Access Compliance Report Public Rights-of-Way (Curb Ramps)

Main Street: HEWES_ST Cross Street: VILLA_PARK_RD Location: S

ADA ID: RPRK211222140900 Ramp Type: Type 1 - Perpendicular Initial Pass/Fail: Fail Overall Compliance: No Severity Score: 15

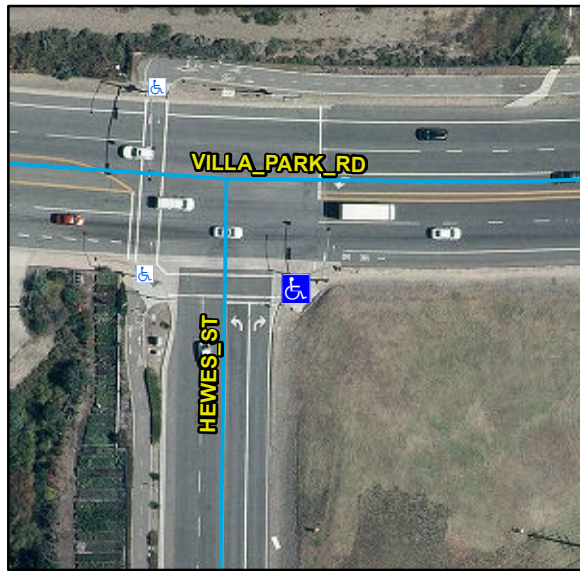
Compliance	Description	Data	Compliance	Description	Data
N/A	Ramp Length (in)	98	N/A	Flare Type LT	
Yes	Ramp Width (in)	48			N/A
No	Ramp Run Slope (%)	8.4	N/A	Flare Slope LT (%)	N/A
Yes	Ramp Cross Slope (%)	2.4	N/A	Flare Traversable LT	N/A
N/A	Landing Present	N/A	N/A	Flare Type RT	
N/A	Landing Length (in)	N/A			N/A
N/A	Landing Width (in)	N/A	N/A	Flare Slope RT (%)	N/A
N/A	Landing Run Slope (%)	N/A	N/A	Flare Traversable RT	N/A
N/A	Landing Cross Slope (%)	N/A	N/A	DWS Provided	N/A
N/A	Landing Movement Obstructed?	N/A	N/A	DWS Contrast	N/A
	Landing Movement Type	N/A	N/A	DWS Length (in)	N/A
N/A	Landing Shared	N/A	N/A	DWS Full Width	N/A
N/A	Clear Space	N/A	N/A	DWS Offset Left (in)	N/A
N/A	Clear Space To Crosswalk (in)	N/A	N/A	DWS Offset Right (in)	N/A
N/A	Marked Crosswalk 1	Yes	N/A	Marked Crosswalk 2	N/A
	Crossing 1 Direction	W		Crossing 2 Direction	N/A
	Marked Crosswalk 1 Width (in)	144		Marked Crosswalk 2 Width (in)	N/A

N/A	Ramp Inside Crosswalk 1	Yes	Yes	Ramp Inside Crosswalk 2	N/A
	Crossing 1 Slope (%)	3.1		Crossing 2 Slope (%)	N/A
	Crossing 1 Cross Slope (%)	3.9		Crossing 2 Cross Slope (%)	N/A
N/A	Gutter Ponding	N/A	N/A	Curb Slope	1.7
Yes	Gutter Lip Height (in)	0		Road Run Slope (%)	N/A
N/A	Gutter Run Slope (%)	N/A		Road Cross Slope (%)	N/A
N/A	Gutter Cross Slope (%)	N/A			
Yes	Overall Surface Condition: Acceptable		Yes	Perp Joint Present	Yes
	Cross Gutter Present?	Yes		Spandrel Present?	Yes
	Replace Cross Gutter?	No		Replace Spandrel?	No

Remove & Replace Entire Ramp.

R304.2.2, STD 1115
